14671 Viburnum Dr.

CALURE RESIDENCE
DAYTON, MD

From: Oswald, Hank
Sent: Thursday, February 09, 2017 8:42 AM
To: 'Paul Mueller Jr.'
Cc: bb121658@gmail.com
Subject: RE: B17000327_14671 Viburnum Drive_Floor Plans

POOL PAVILION FLOOR PLAN

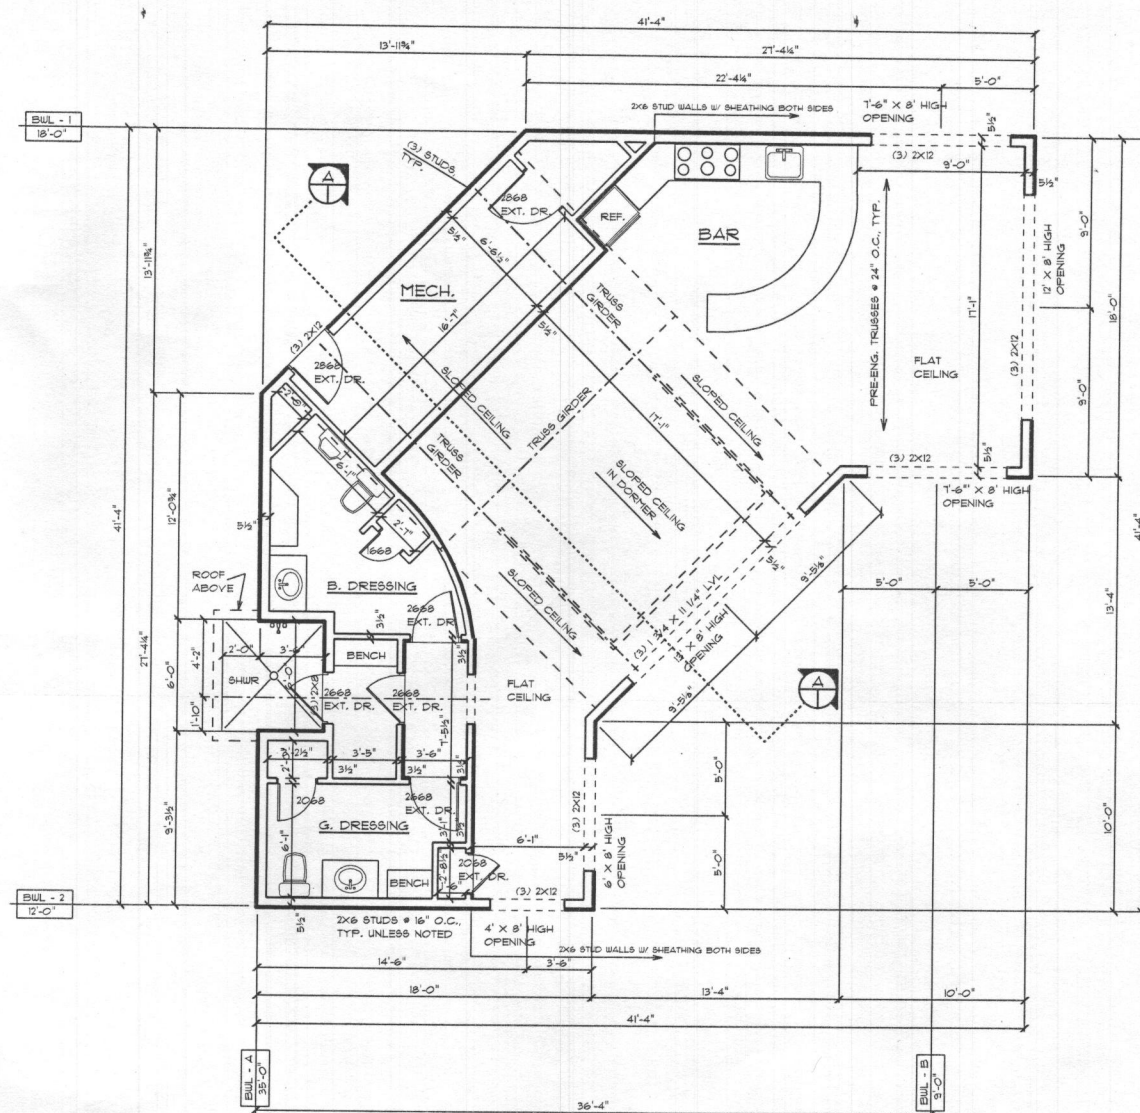
The septic plan that I recently reviewed was sized for 6 bedrooms. Based on the floor plans that you submitted yesterday, the room above the detached garage and the pool house will also be counted as bedrooms. The septic plan will have to be sized for 8 bedrooms unless you decide to make changes to the floor plans. Also, the building permit will need to be revised to indicate a total of 8 bedrooms.

Basement – 1 bedroom
First – 1 bedroom
Second – 4 bedroom
Detached Garage – 1 bedroom
Pool House – 1 bedroom
